**From:** Craig Rohe <craig@ucc.com>  
**Sent:** August 20, 2019 3:25 PM  
**To:** Curtis Thompson; Jason Schooley; John  
**Cc:** Derek Young; Barbara Wiens; Jason Marr; Tolga Aydin; Taylor Boyle (taylor.boyle@niagararegion.ca)  
**Subject:** RE: 2nd Submission Comments - 1 Hwy 20 West (SP-05-19)  
**Attachments:** 1842-BASE-SSGP-R6.pdf

**Subject:** RE: 2nd Submission Comments - 1 Hwy 20 West (SP-05-19)

### **Submission for Site Plan Application – 3<sup>rd</sup> Submission**

**1 HWY 20 WEST, Fonthill**  
**TOWN OF PELHAM**  
**SITE & LANDSCAPE PLAN**

Figure 1: Depending upon existing soil conditions, the tree pit may require a drainage connection to the nearest catch basin:

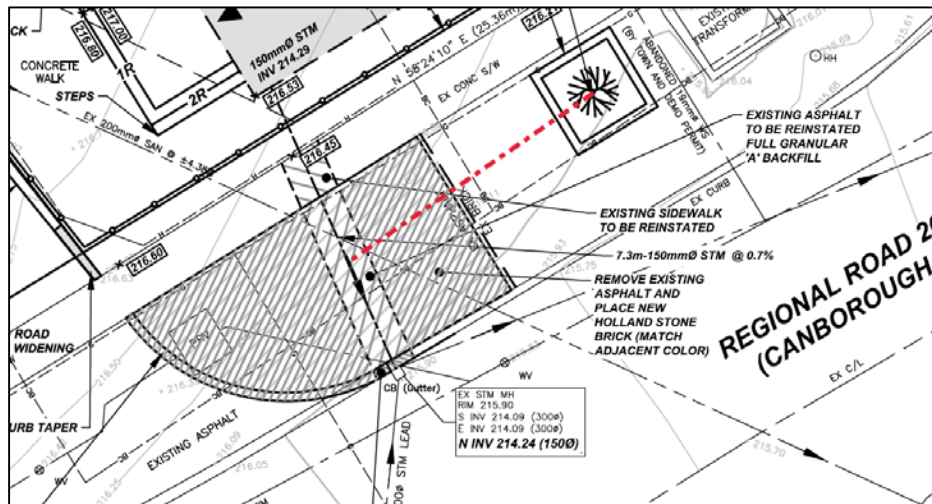
Staff require that the developer revise the Site and Landscape Plan to include the following information:

- a. Planting Detail for the proposed street tree and perennial ground cover. Ensure that the deciduous tree detail identifies the depth of the tree pit and reflects the site specific condition of a 2m x 2m concrete curb, surrounded by unit pavers. Additionally, if clay or poorly drained soil is present, then a drainage connection may be required from the tree pit to the proposed storm lateral.
- b. Plant List for proposed plant material, including a perennial ground cover within the tree pit (refer to the Town's comments on this item, dated July 25, 2019).

**Note:** Planting details and plant lists are a typical requirement for a streetscape / landscape plan.

Figure 2: Remove 1 riser and replace with either ramp or place a railing along this edge

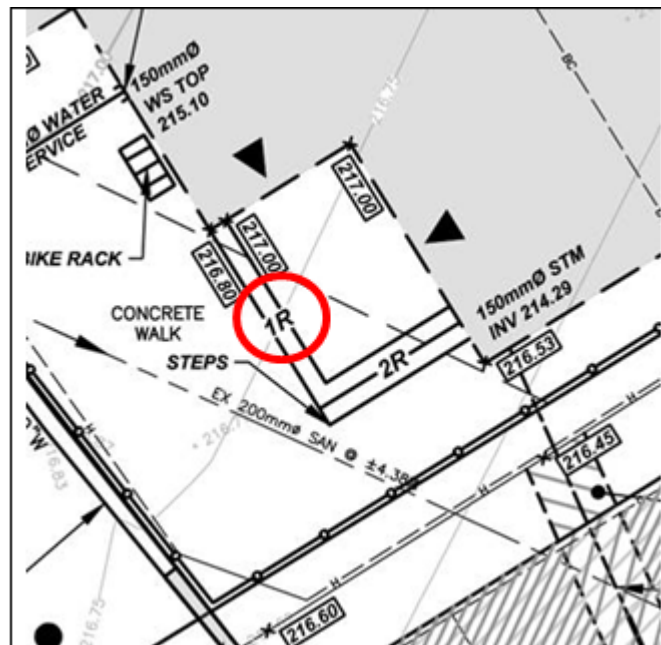
Staff still recommend that the condition of 1 riser in the south-west corner of the site be removed and replaced with a ramp or railing. The design of a single step is not a best practice in site design and could be a potential tripping hazard.

We took out the single riser. Likely will put some planters there to delineate the edge.

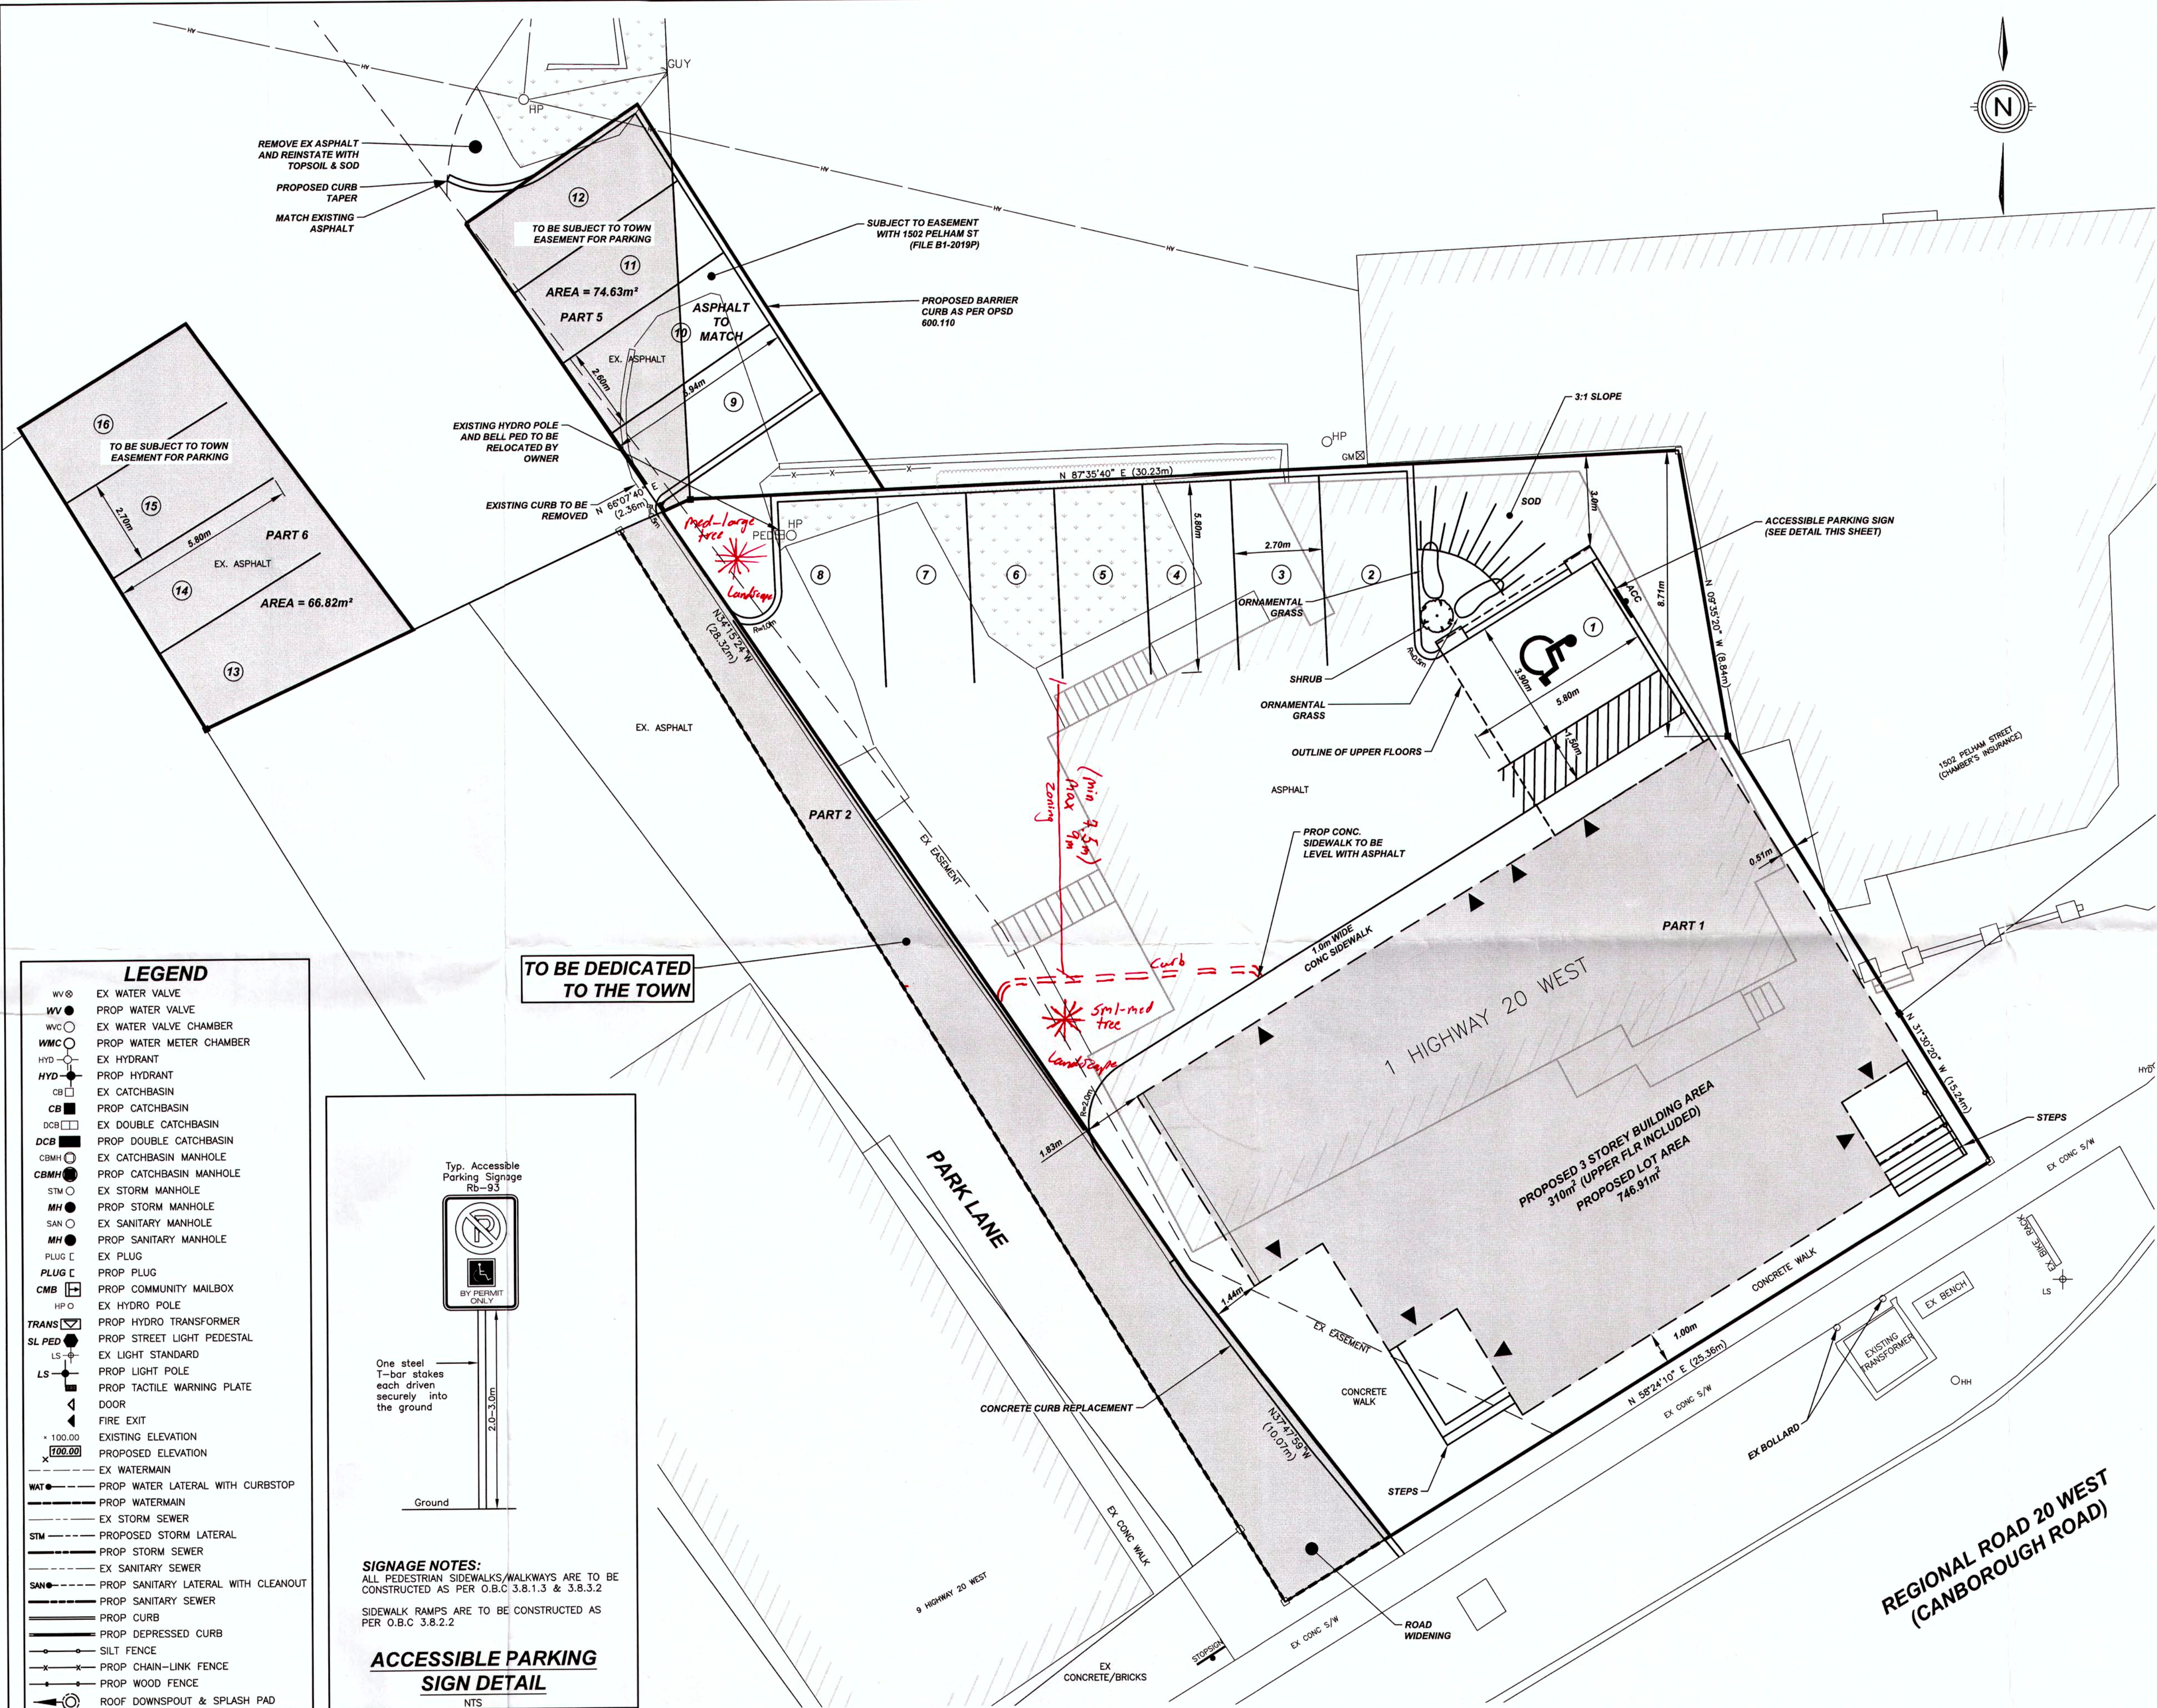
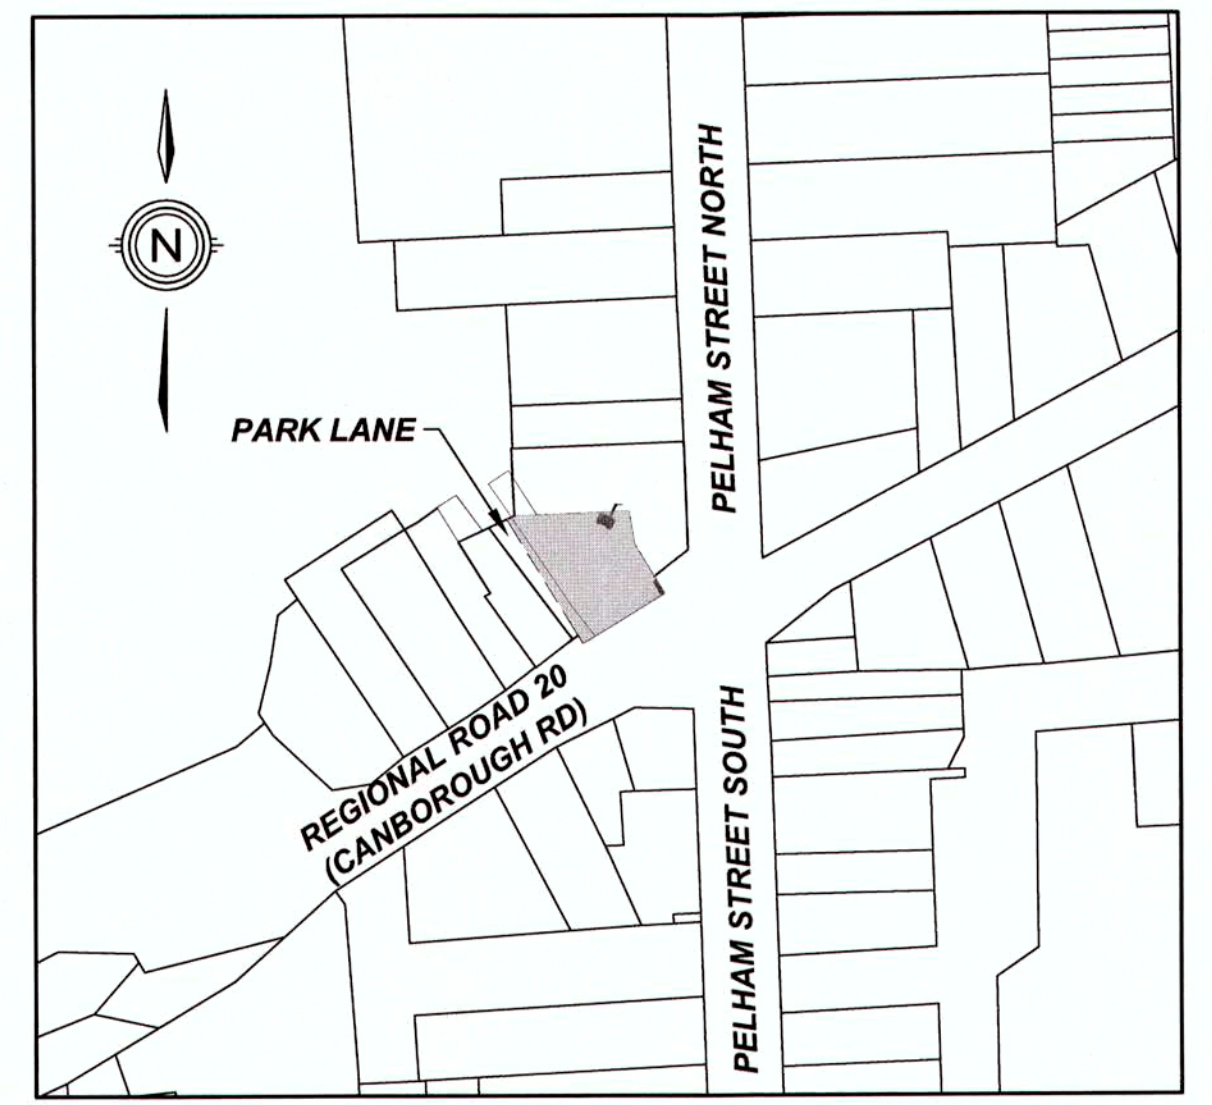
- On-site and off-site cost estimates are required for the Site Plan Agreement.
- (Refer to attached markup)
- Please illustrate and reduce the size of the Park Lane driveway apron (curb cut) along the Highway 20 frontage, (as per Regional comments) and provide for street tree(s).
  - Salt tolerant trees could include:
    - Sycamore / Celebration / Autumn Blaze Maple
    - Common Hackberry
    - Black Gum
    - Bitternut / Shagbark Hickory
    - Shagbark Hickory etc.
- Consider providing bicycle parking racks in one (or more) visible locations around the proposed building.
- Locate one (1) medium to large sized deciduous tree on the landscape boulevard beside parking stall #8 and another tree on the other landscaped island (using native species).

- See attached Site Plan Markup. (Maximum drive aisle width of 9 m)
